REQUEST: An application to create one 2.068-acre lot from a tract of land in City Block 6142 on property located on Harry Hines Boulevard, west of Denton Drive.

Case no: S223-247

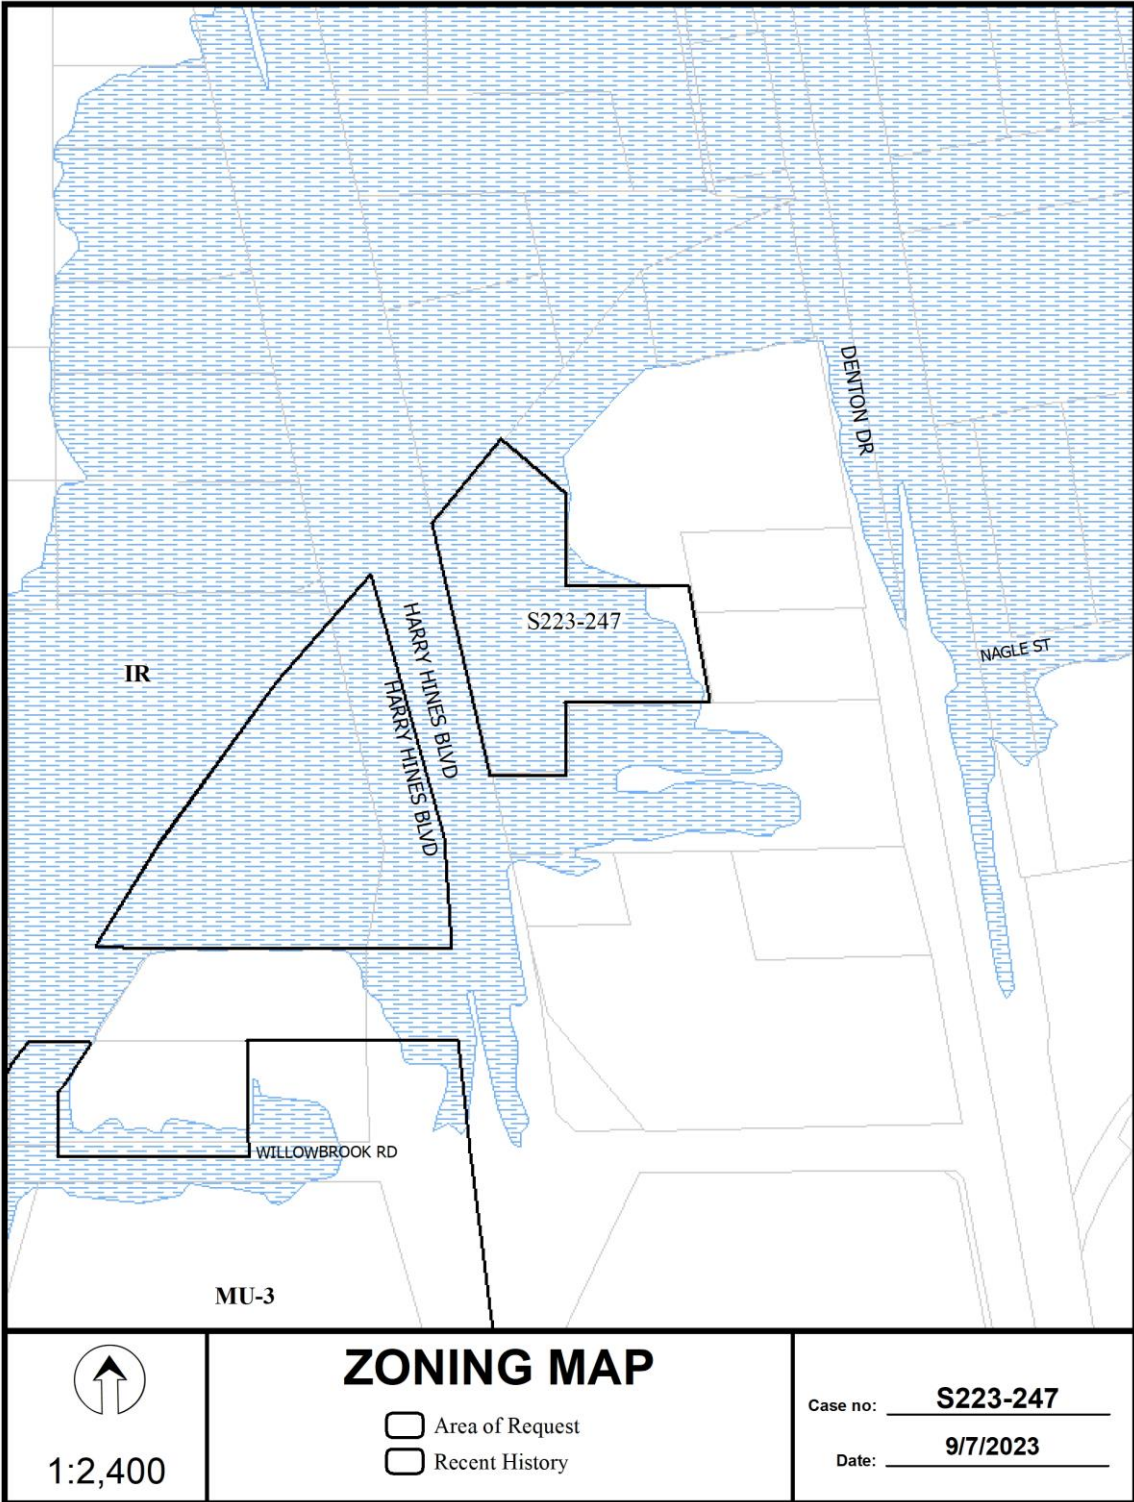
24. On the final plat, show recording information on all existing easements within 150 feet of the property.
25. On the final plat, show all additions or tracts of land within 150 feet of property with recording information.
26. Need new/different plat name.

29. On the final plat, change “Harry Hines Boulevard” to “Harry Hines Boulevard /State Highway Loop No. 354.”
30. On the final plat, identify the property as Lot 5 in City Block 6142. Ordinance 1A, Page 131 pages 131-148, Section 2 (passed August 13, 1872).
